September 17, 2021

SUBJECT: Conditional Approval of Remedial Action Plan under Wis. Admin. Code § NR 724.09 and Materials Management Plan under Wis. Admin. Code § NR 718.12
Riverpoint District - LGU, North 10th Street and Buffalo Street, Manitowoc, WI 54220
BRRTS #: 02-36-585491

SURVEY: CORNER POINT
 DRAWN: JMV
 DESIGNED: JMV
 CHECKED: MAB
 APPROVED: JAW
 PROJ. NO.: 193805824
 SHEET NUMBER: **C2.01**

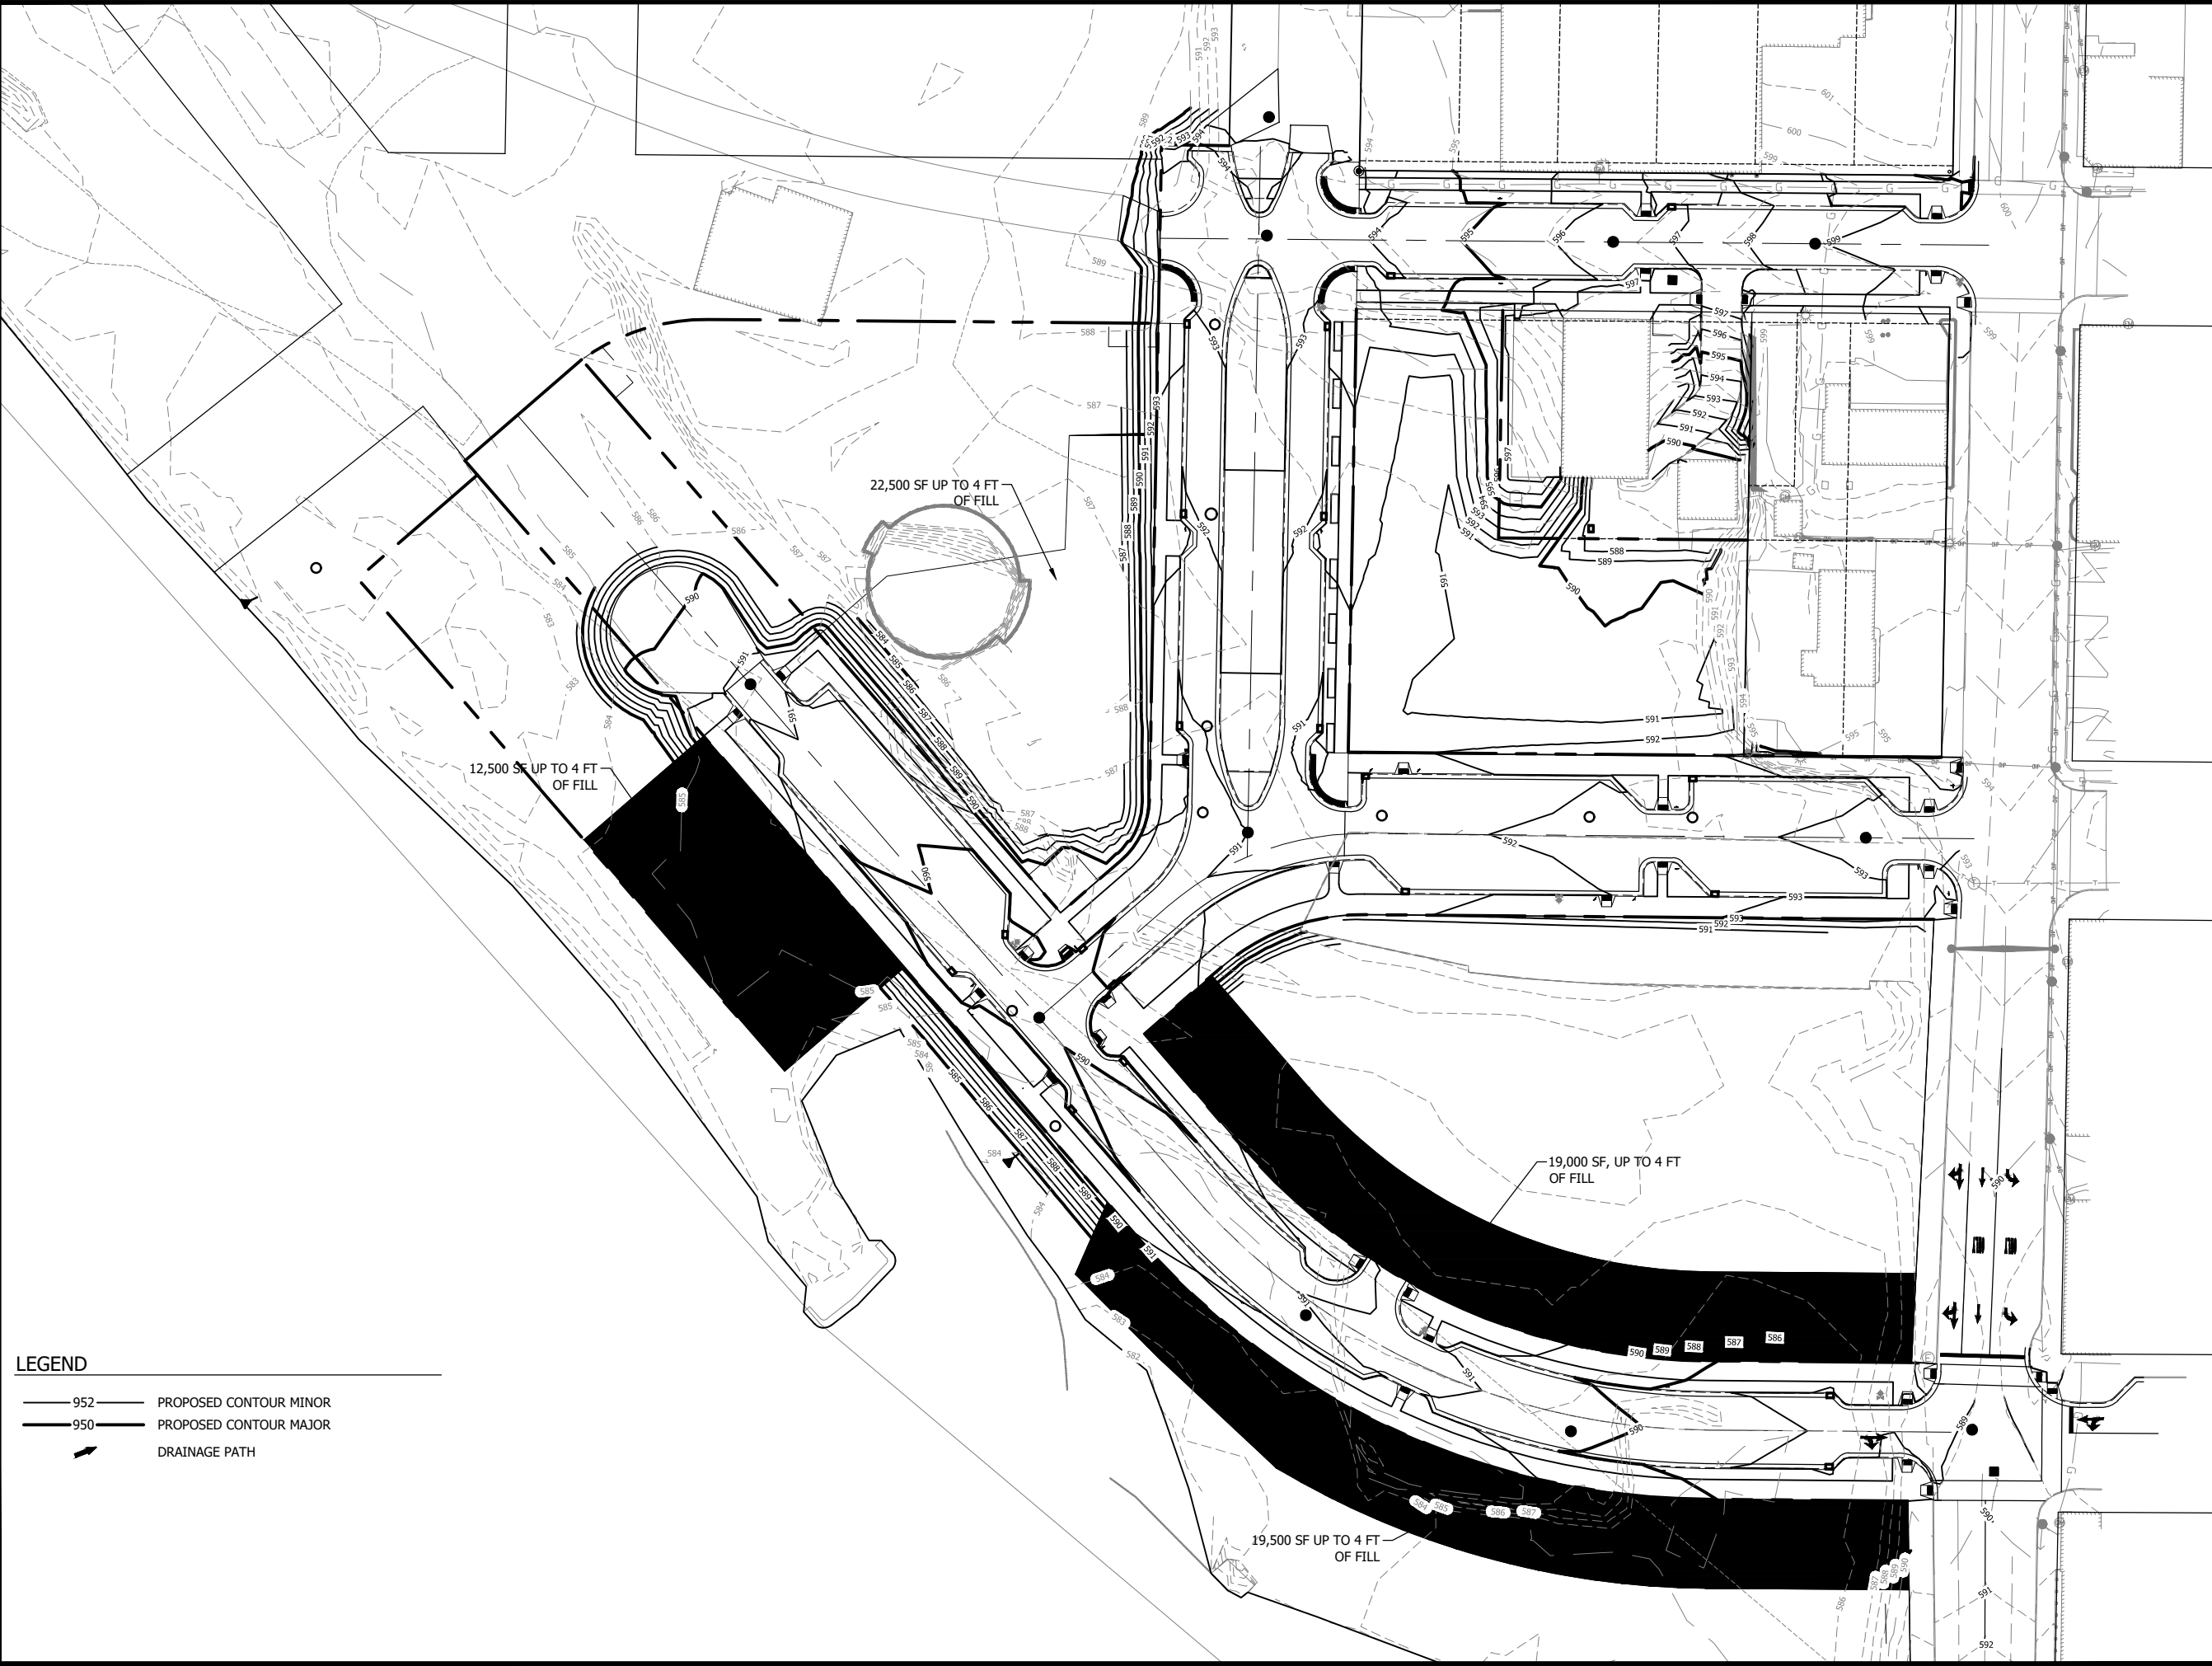
- In addition to the petroleum impacted soil proposed to be disposed at a landfill, any PCB impacted soil that was found during the site investigation and any chlorinated VOC impacted soil known from the former roundhouse area from the closed case, W C L Turntable Former Roundhouse, BRRTS # 02-36-176478, that will likely be encountered during utility installation in the proposed North 11th Street ROW will also need to be taken to the landfill.

- The DNR will not require a cap maintenance plan for the public road ROWs, as it will already be maintained by the municipality as a road ROW.
- The DNR has determined that a Post-Closure Modification Request for the closed case W C L – Turntable Former Roundhouse, BRRTS # 02-36-176478 will need to be submitted with the RAP for when the remainder of the cap area from the closed case is proposed to be modified during future redevelopment and the change from industrial zoning and land use to a non-industrial zoning and land use.
